J2127A-08

S E R V I C E N O T E

Agilent J2127A Transmission Test Set

Incorrect operation of Signal Wizard at STM-0 due to incorrect fitting of resistors

Location of R725 on J2125-63003 Board

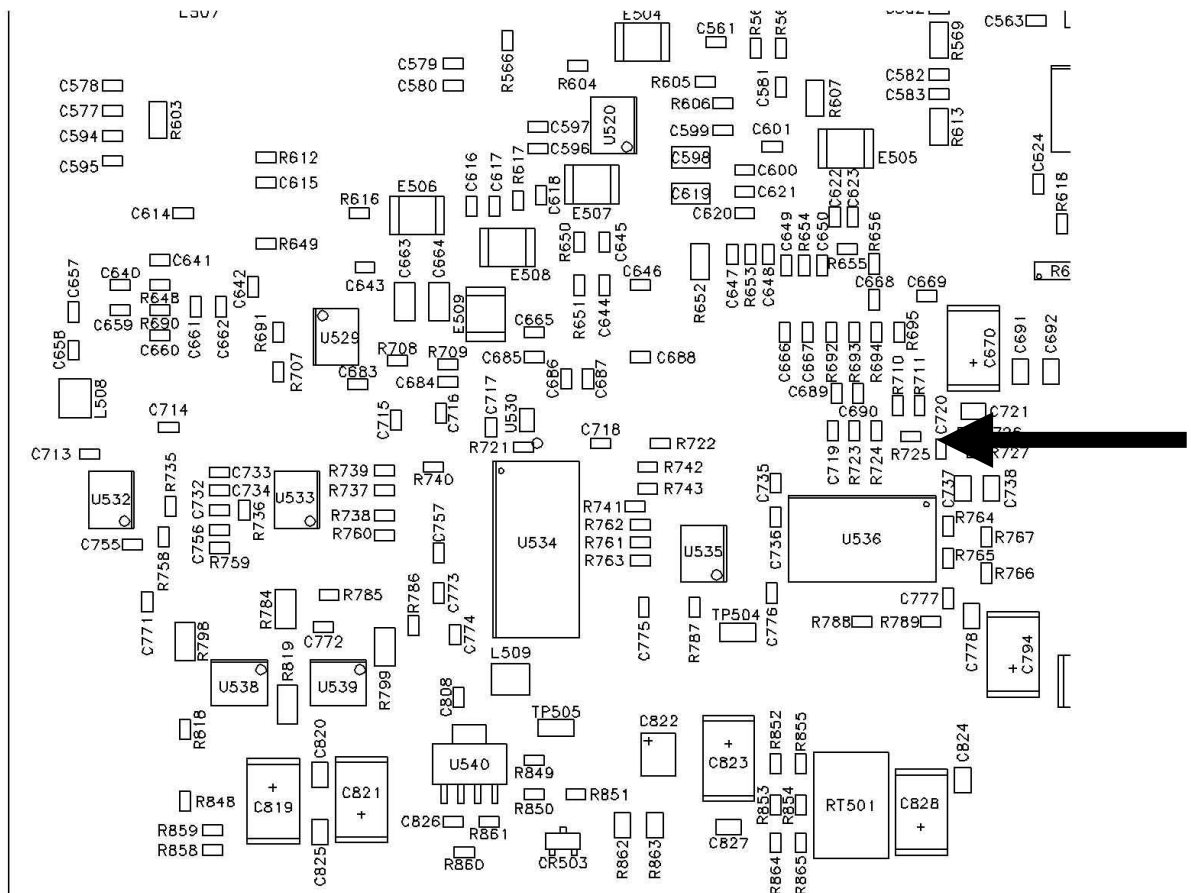
A batch of instruments were shipped with the wrong value resistors fitted to the Digital Board (p/n J2125-63003). This causes incorrect operation of the instrument's Signal Wizard feature at the STM-0 signal rates. All other signal rates are unaffected.

1. Remove the instrument top panel by unscrewing the four corner screws.
2. Lift off the instrument top panel.
3. Remove the Digital Board. The board is the rear-most board in the instrument cardcage.
4. Locate resistors R725 and R797. Use the following illustrations as a guide.

5. Replace R725 with 100 ohm resistor 0699-3924 and resistor R797 with 0 ohm resistor 0699-3574.
6. Replace the Digital Board and instrument covers by performing the reverse of steps 1 to 3. Ensure the screws on the cover are tightened to a torque of 0.15Nm maximum. Ensure the screws securing the instrument top cover are tightened to a torque of 2.8Nm
7. End of procedure.
